STAFF RECOMMENDATION
1917 Holly Street
September 16, 2020

Application: New Construction—Infill
District: Lockeland Springs-East End Neighborhood Conservation Zoning Overlay
Council District: 06
Base Zoning: R6
Map and Parcel Number: 08314002300
Applicant: Zoie Babb; Builder Assist, LLC
Project Lead: Sean Alexander, sean.alexander@nashville.gov

<p>Description of Project: A proposal to construct a new house, replacing a structure that was demolished by the tornado on March 3rd. The new building will be one story tall.</p> <p>Recommendation Summary: Staff recommends approval of the proposed infill and outbuilding at 1917 Holly Street with conditions that:</p> <ol style="list-style-type: none"> 1. The finished floor height shall be consistent with the finished floor heights of the adjacent historic houses, to be verified by MHZC staff in the field; 2. The front setback shall be consistent with the setbacks of the adjacent historic houses, to be verified by MHZC staff in the field; 3. The porch columns shall have minimal bases and capitals; and 4. Windows in multiple sets shall have a four-inch (4”) mullion between them; 5. The window and door selections shall be approved by MHZC Staf

1 SITE PLAN
1/16" = 1'-0"

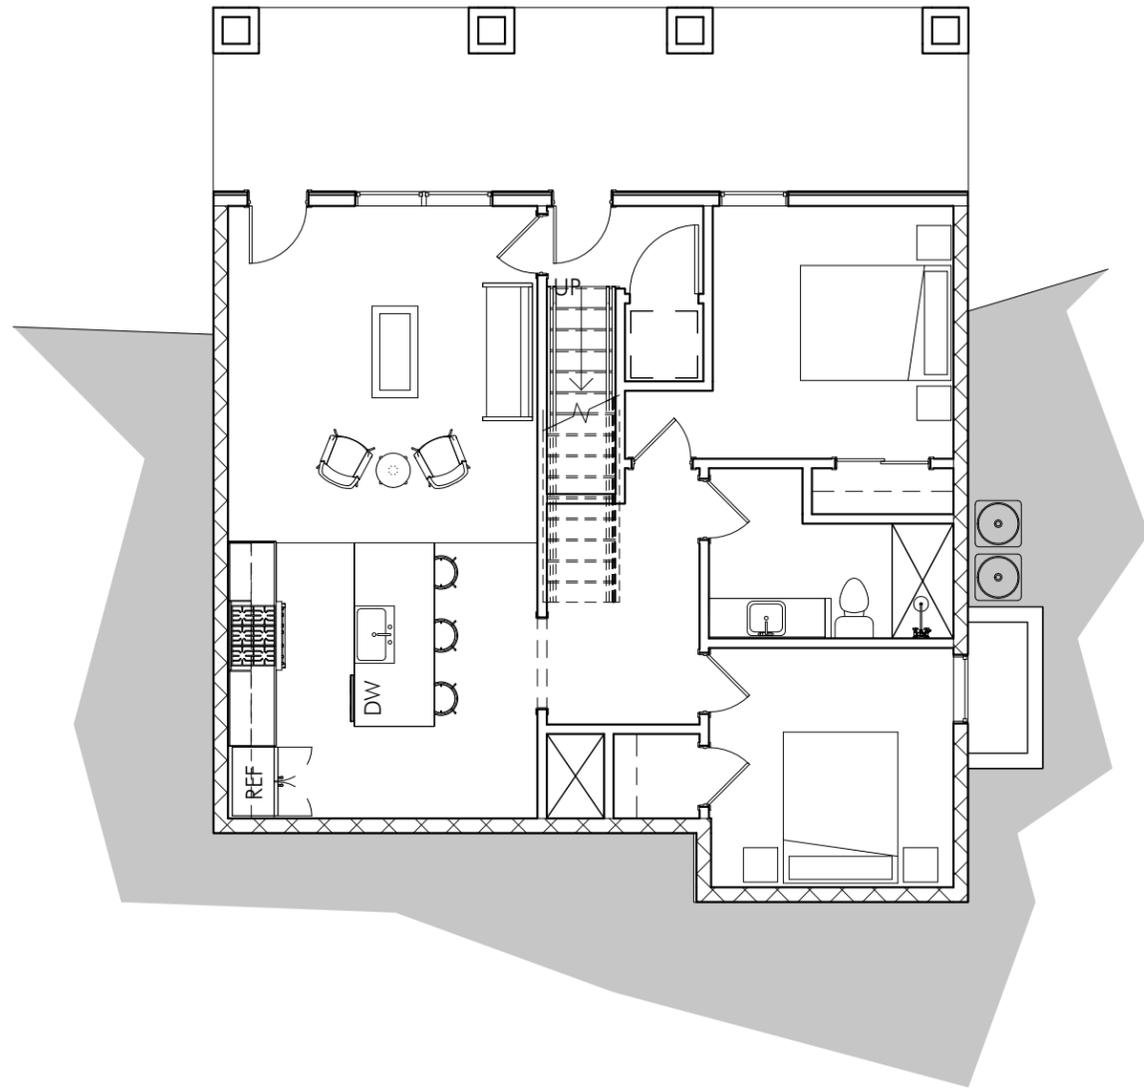
Setback & Rhythm of Spacing: The front edge of the building is proposed to be forty-two feet (42') from the front of the lot, matching the front setback of the previous building. The building's side setbacks will be fourteen feet (14') on the right side and thirteen feet (13') on the left. This meets bulk zoning requirements and is consistent with the rhythm of spacing in the historic context.

Appurtenances & Utilities: A front walkway will connect the front steps to the front of the lot. An existing shared driveway on the left side of the lot will be retained, with an extension to the rear of the lot alongside the house. The HVAC units are shown to be located on the right side of the house at the midpoint.

With a condition that Staff shall verify the front setback at the start of construction, Staff finds that the front and side setbacks will meet section II.B.3 of the design guidelines.

1. The finished floor height shall be consistent with the finished floor heights of the adjacent historic houses, to be verified by MHZC staff in the field;
2. The front setback shall be consistent with the setbacks of the adjacent historic houses, to be verified by MHZC staff in the field;
3. The porch columns have minimal bases and capitals; and
4. Windows in multiple sets shall have a four-inch (4”) mullion between them;
5. The window and door selections shall be approved by MHZC Staff;
6. The roof color shall be approved by MHZC Staff.

HOLLY STREET ELEVATION

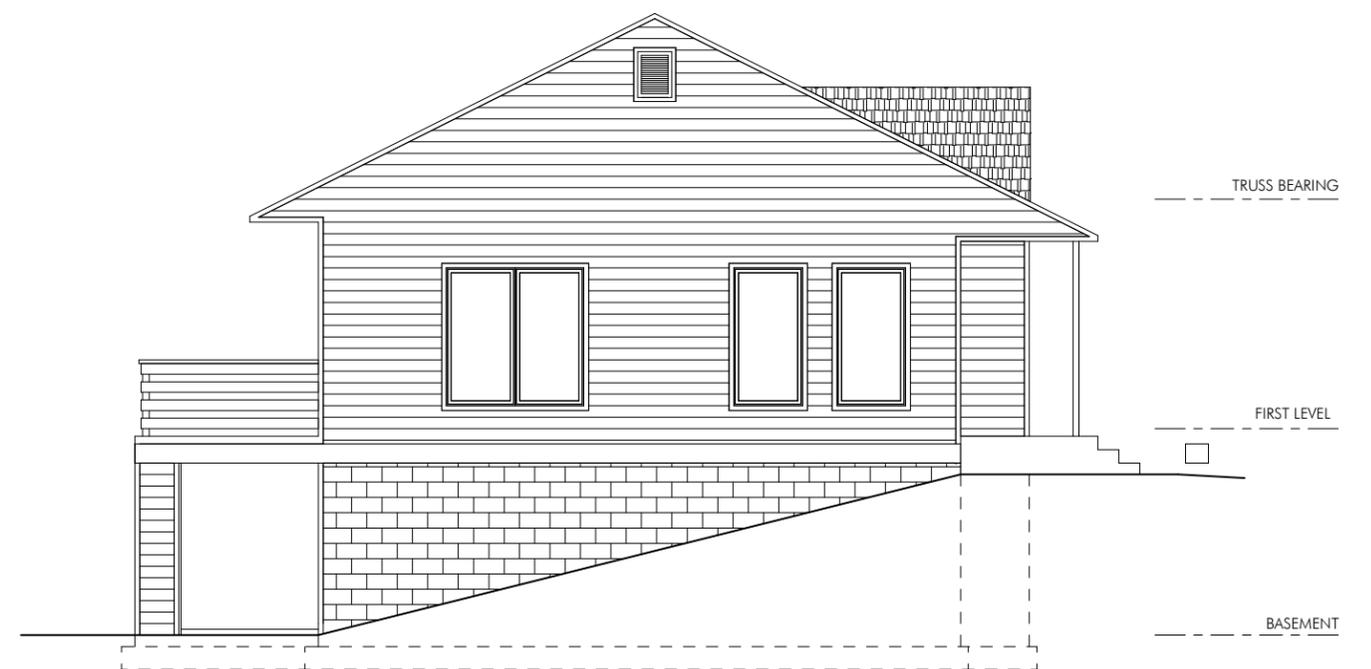
Height & Scale: The new principal building will be one-story tall, with a roof-ridge height of twenty feet (20') from grade and an eave height ten feet (10') from grade, with a foundation height of one foot (1'). The historic context on this block is composed of one-story and one and one-half story houses, ranging from thirteen feet (13') to thirty-five feet (35') tall. Staff finds that the height of the proposed new building is compatible with the surrounding context.

Roof form: The primary roof of the building will have a side-gabled form with a pitch of 6/12, with a front projecting accent gable on the right side. This roof form and pitch is typical of roofs on historic houses nearby. The roof includes solar panels on the rear slope. Solar panels have been routinely approved, especially when located in a minimally visible location like the proposed.

Round steel tubes are not a common material for porch columns. The tubes are paired, which together help to provide the width typically seen of a single porch column. Staff

finds that the pair could be a modern interpretation of a historic post if a contemporary cap and base is added to the pair. Historically, paired porch columns would sit upon a shared plinth, or would have individual minimal bases and capitals.

Proportion and Rhythm of Openings: There will be four bays on the front façade of the house, with a door in the center. Staff finds that additional windows are compatible with the historic context. Both of the side elevations will have two-bays, evenly spaced but not matching. There will be two paired sets of windows on the front and another paired set on the left side. Staff recommends that there shall be a four inch (4”) mullion between paired windows, as is typical of windows on historic houses.

With a condition that the steel tube columns have bases and capitals and that staff shall approve the window and door selections as well as the roof color and brick selection, staff finds that the proposal would meet section II.B.4 of the design guidelines.

With a condition that four inch (4”) mullions are added between abutted windows, staff finds that the proposal will be compatible with the surrounding context and that the project will meet section II.B.7 of the design guidelines.
